Staff Summary Report

SUBJECT: BRYAN RESIDENCE #SBD-2002.52

BRIEF: Request by Bryan Residence for an Amended Final Subdivision Plat of University Park Addition for two lots at 117 East 15th Street.

PARCEL MAP FOR A MINOR LAND DIVISION

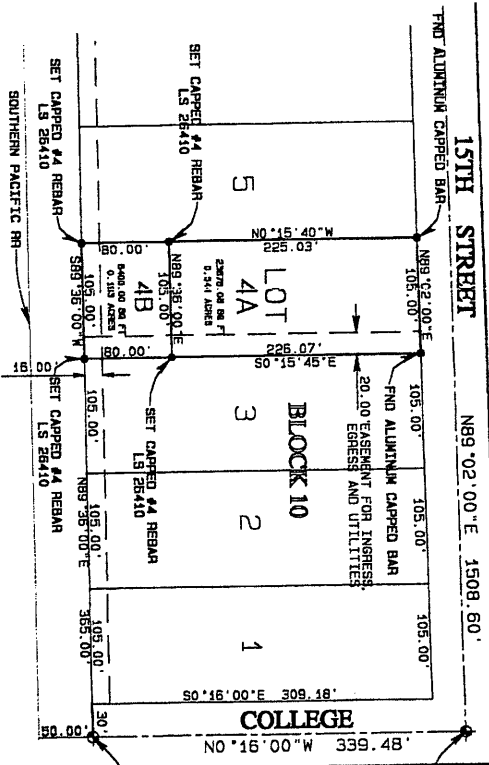
1. The proposed re-plat appears to meet the minimum requirements of Subdivision Ordinance 99.21.

3. No variances may be created by future property lines without the prior approval of the City of Tempe.
4. The Amended Final Subdivision Plat shall be recorded prior to the issuance of permits, and shall show cross access to the interior lot. Failure to record the plan within one year of Council approval shall make the plan null and void.
5. The Amended Final Subdivision Plat shall be put into proper engineered format with appropriate signature blanks and recorded with the Maricopa County Recorder's Office through the City of Tempe's Development Services Department **on or before August 8, 2003**. The Planning Division prior to recordation shall review details of the document format.
